# Modification of Development Consent

**Development Consent:** SSD-10436 granted by the then Minister for Planning and Public Spaces on 31 March 2021

#### **Modification 4**

**Modification Application:** SSD-10436-Mod-4

**Figure 1: Site Plan**

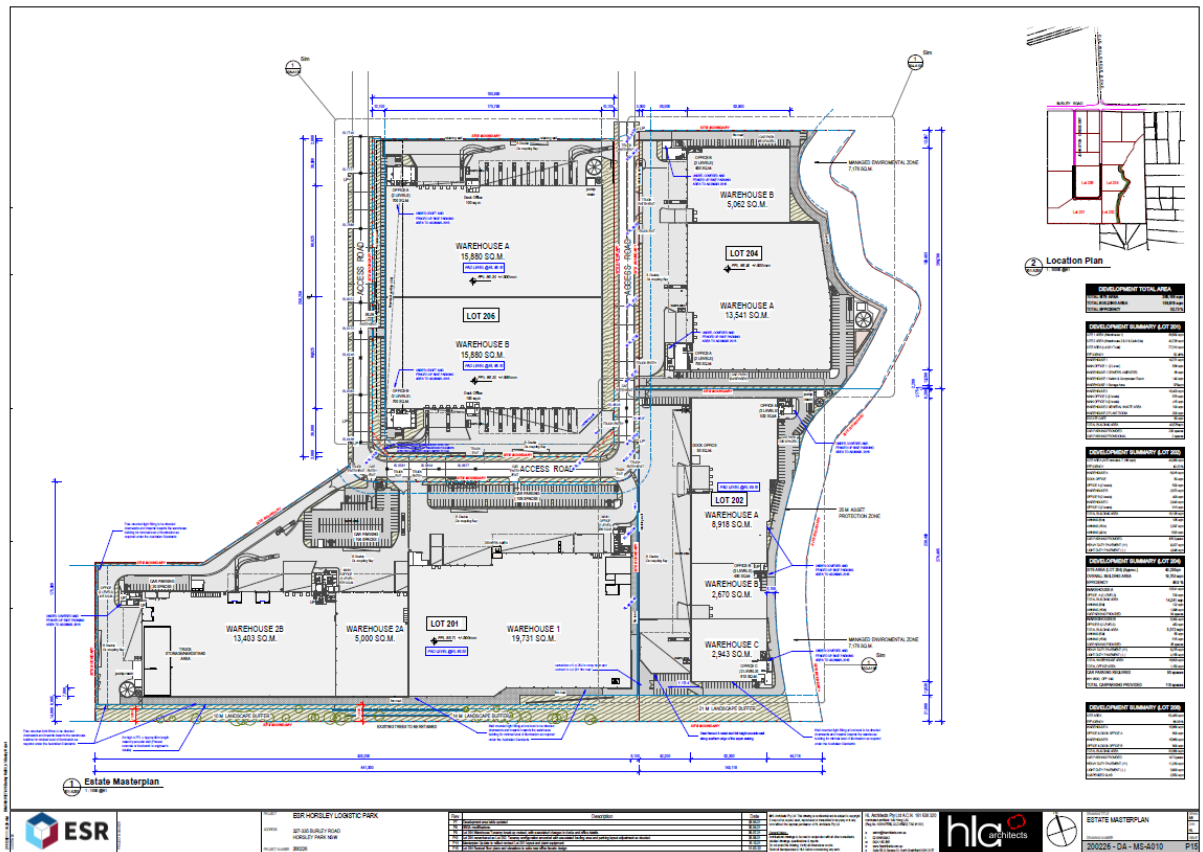
11. Replace Figure 1 with the following:

Figure 4: Lot 204 Plan

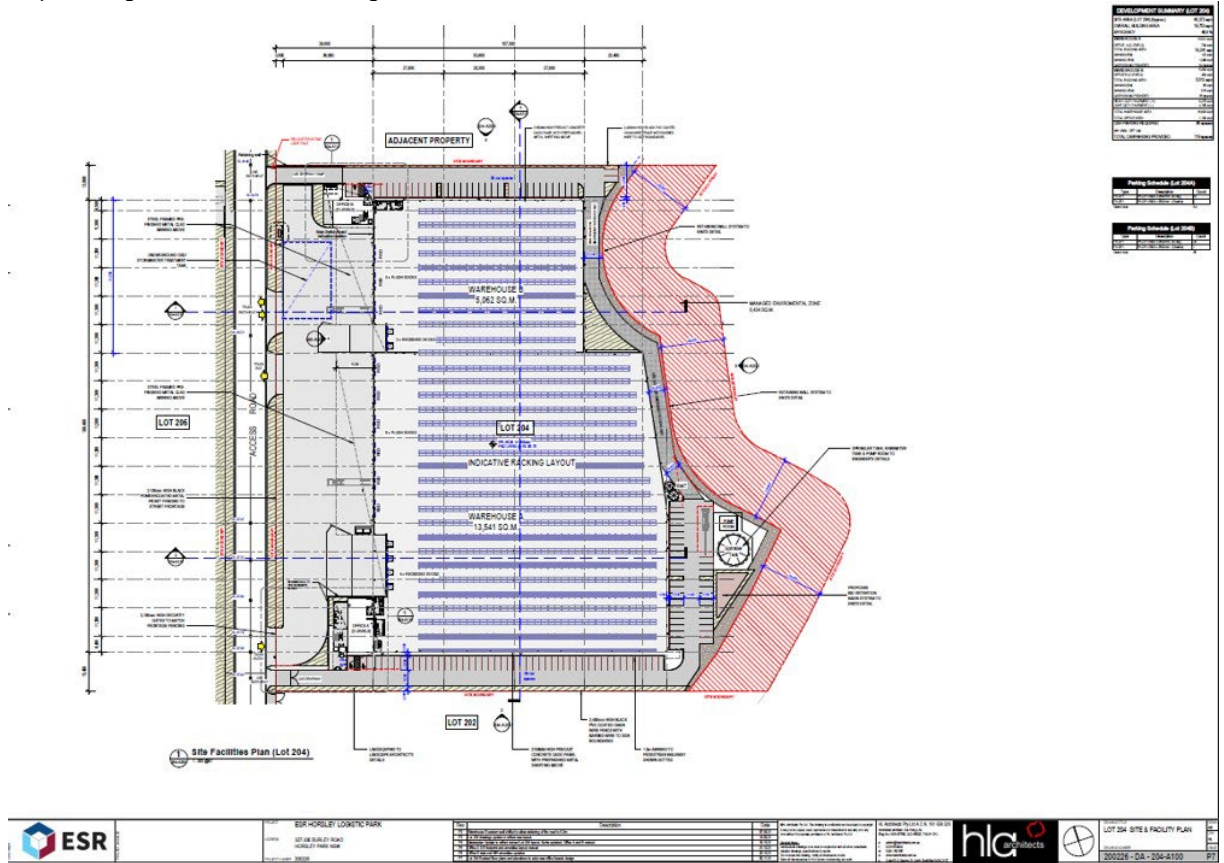
13. Replace Figure 4 with the following:
